From: "David Henkin" <dhenkin@earthjustice.org>
To: <NRCREP@nrc.gov>
Date: Fri, Feb 9, 2007 4:10 AM
Subject: Docket 030-36974

Here are Earthjustice's comments, with select enclosures, on behalf of Concerned Citizens of Honolulu re: the Draft Environmental Assessment and Finding of No Significant Impact for Proposed Pa'ina Hawaii, LLC Irradiator in Honolulu, Hawaii. A hard copy of our comments, with a complete set of enclosures, has been sent by priority U.S. mail.

Earthjustice submits these comments on behalf of the Concerned Citizens of Honolulu in response to the Nuclear Regulatory Commission's ("NRC's") December 28, 2006 request for comment on the Draft Environmental Assessment and Finding of No Significant Impact for Proposed Pa'ina Hawaii, LLC Irradiator in Honolulu, Hawaii ("DEA"). See 71 Fed. Reg. 78,231 (Dec. 28, 2006). In preparing these comments, Earthjustice was assisted by Drs. George Pararas-Carayannis, Marvin Resnikoff, Mete Sozen, and Christoph Hoffmann, who prepared separate reports critiquing aspects of the DEA and the Draft Topical Report on the Effects of Potential Natural Phenomena and Aviation Accidents at the Proposed Pa'ina Hawaii, LLC, Irradiator Facility

Figure 4. Model framing of steel structure and pool lip.

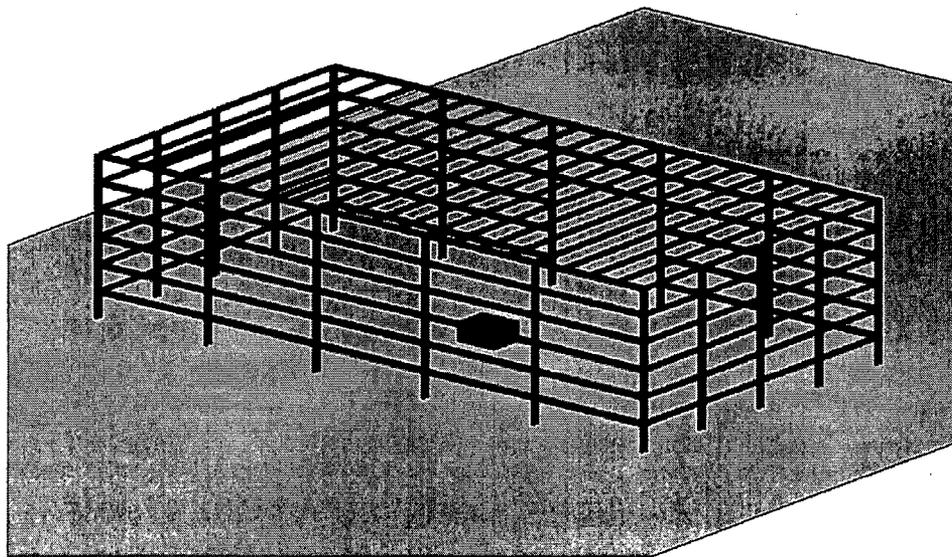
The structure of the building was modeled as a ductile moment-resisting frame with perfect continuity at the joints and at the bases of the column. Because the actual properties of the building are unknown (due to Pa'ina's failure to provide construction plans), these conservative assumptions were employed to create a model structure that is stronger than what is likely to be achieved in practice. In other words, the proposed irradiator, if built, would suffer greater damage in the modeled aircraft collision than the structure used in this analysis.

Normal specifications were also assumed. The columns (14WF48) and the girders (12WF40) were modeled as structural steel with a normal yield strength of 345 MPa (~50,000 psi) and a limiting unit strain of 40%. Columns were spaced at 24 feet in the long and 16 feet in the short direction of the structure. Height to the roof was set at 30 feet, and the roof girders were spaced at 6 feet. A total of ~210,000 elements were used in the modeling of the building. The framing is shown in Figure 4.

The irradiator pool is modeled as made of a 1/4-inch stainless steel inner tank connected by welded I-beams to a 1/4-inch carbon steel outer tank, with a 42-inch lip extending above the facility floor. The space between the pool's inner and outer steel tanks is modeled as filled with concrete with a yield strength of 4,000 psi.

Figure 5. Impact of B767 with steel structure at 100 mph.

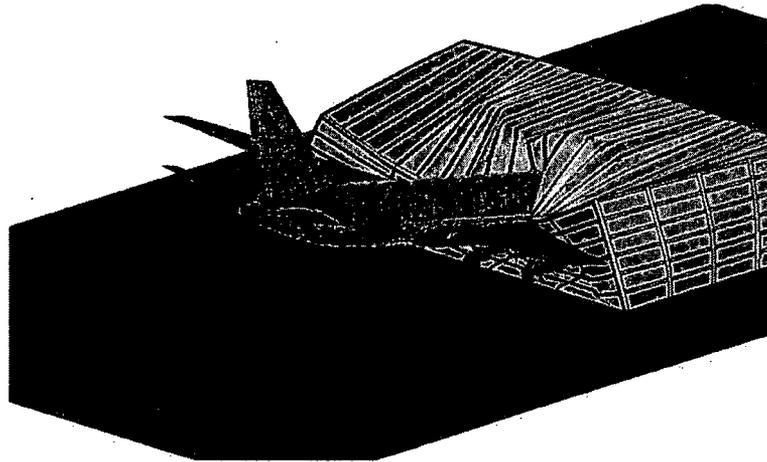
The aircraft was assumed to impact the structure head-on while traveling on the ground at a speed of 100 mph.² The “flight path” was assumed to be parallel to the ground and perpendicular to the rear façade of the structure. As depicted in Figure 5, the calculations indicated that the aircraft will crash through the columns and girders of the building. Impact of the structure at any angle would produce similar results.

Because the building was modeled with a toughness that could not be achieved in practice, this simulation results in acute bending of the columns and the girders, visible in Figure 5. Under actual conditions, many of the columns and girders would fracture or be torn off the connections. Debris and fuel would fill the structure, and the fuel would be expected to ignite explosively, causing a massive conflagration. The total damage within the structure would depend on the existing fire load, including the fuel load and the flammable materials within the building. However, the fire is likely to soften all metals, burn all non-metals, and deteriorate the concrete. This could result in a breach of both the source assemblies and the pool, allowing shielding water to escape. The Co-60 sources could also be exposed if extreme temperatures evaporate the pool water or if the force of the impact disperses the source. In addition, all personnel in the building would likely be killed or incapacitated in the event of a crash and conflagration, and Pa'ina Hawaii's proffered emergency procedures would be rendered useless, because no personnel would be there to implement them.

Figure 3. Airport Diagram Honolulu International Airport

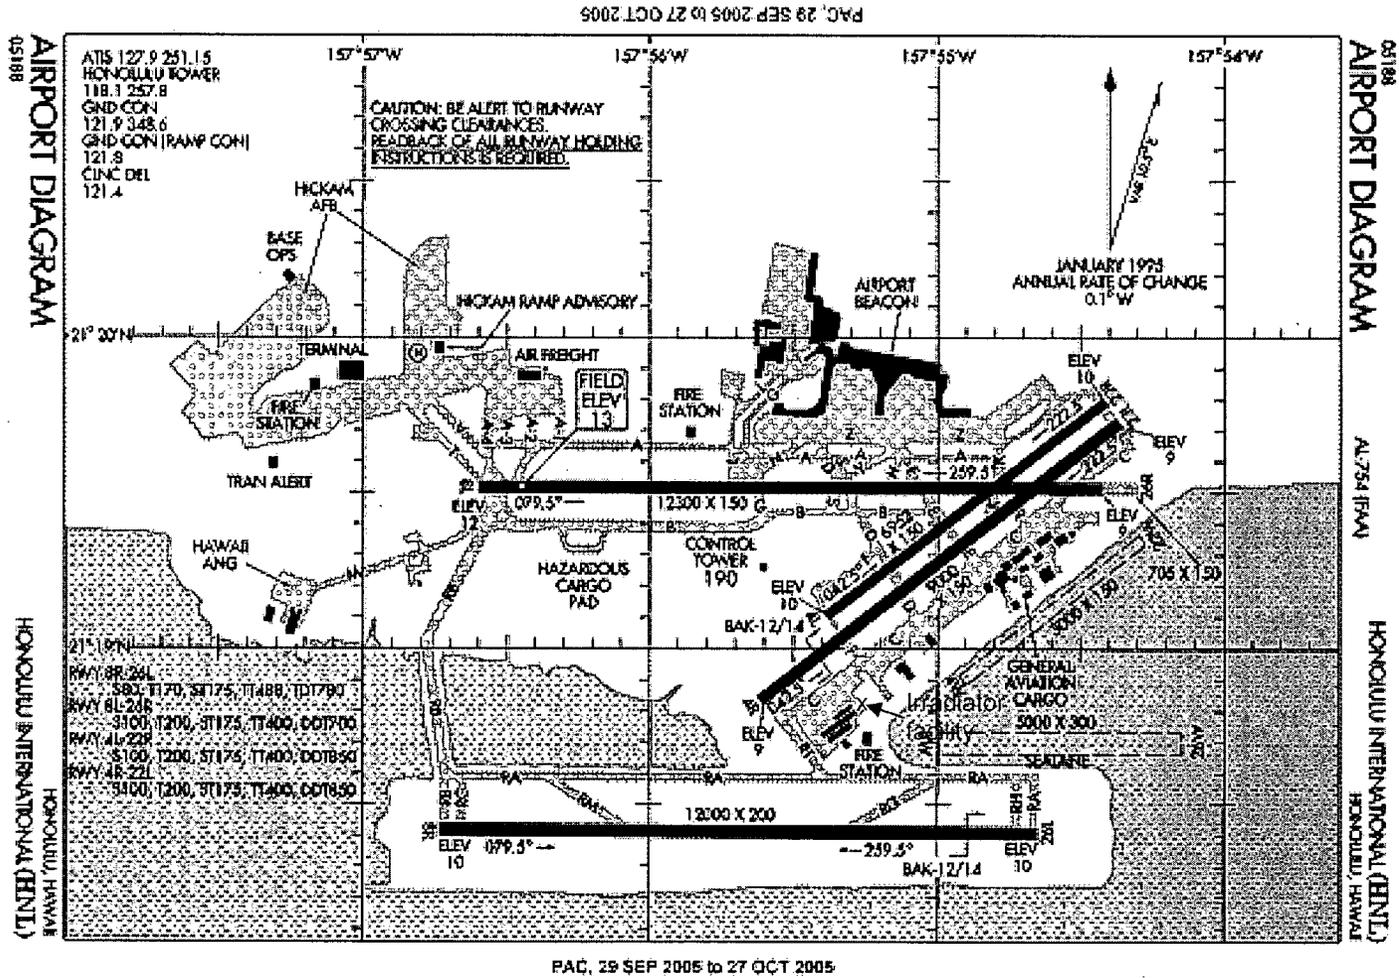
As seen in Fig. 3, the proposed facility is located extremely close to and lies between the runways (4R,22L) and (8R,26L), the reef runway. It is approximately $\frac{1}{4}$ mile from each runway and a little more than $\frac{1}{2}$ mile from the major runway (8L,26R). Table 7 lists the distances of the proposed facility from the center of each of the four runways. The conditional probability distributions are probability estimates in one square mile blocks. That is, given a crash, the conditional probabilities provide the probability that the crash takes place in an area of one square mile. As seen in Table 7, the centers of all runways are within one mile of the proposed facility.

Map 19: Airport to Waikiki

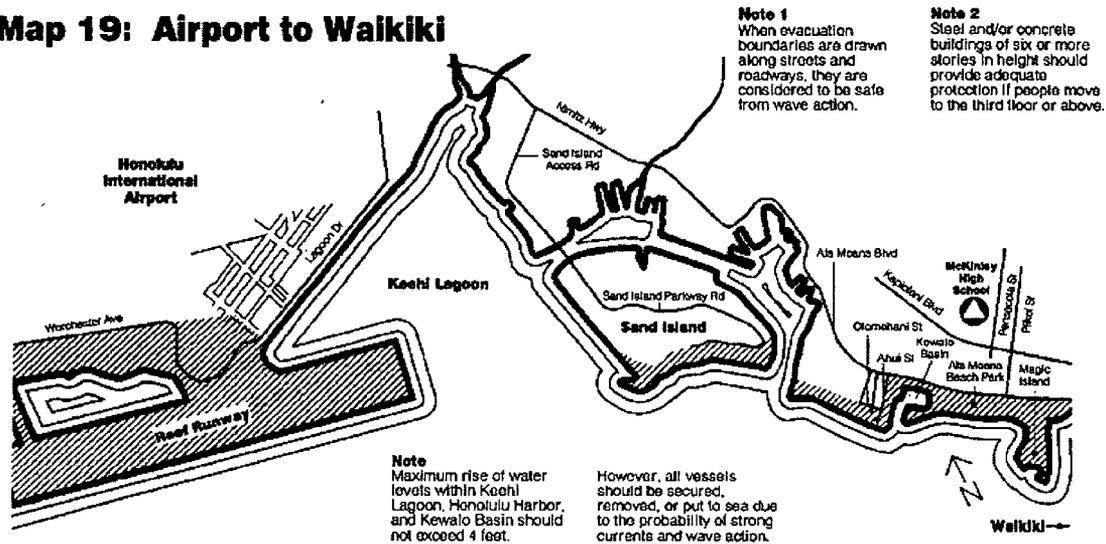
Map 19, provided below, indicates that the tsunami evacuation zone currently extends to the ‘ewa (west) side of the last street on Lagoon Drive. Because Palekona Street is the last street on Lagoon Drive, and the proposed Irradiator site is on the ‘ewa side of Palekona Street, the proposed Irradiator site is within the tsunami zone. Map 18 and 19 also show that the entire reef runway is within the tsunami zone.

Tsunami Evacuation Limits – The EA and the CNWRA Report both fail to assess or even mention the fact that the proposed Irradiator site is in a tsunami evacuation zone, based on the Civil Defense maps. Also, the CNWRA Report incorrectly states that the O‘ahu Civil Defense Agency tsunami flood maps (2006) show the Honolulu International Airport above the tsunami evacuation zone. The Civil Defense maps in fact show that the reef runway and some peripheral airport facilities are within the zone of potential tsunami inundation.
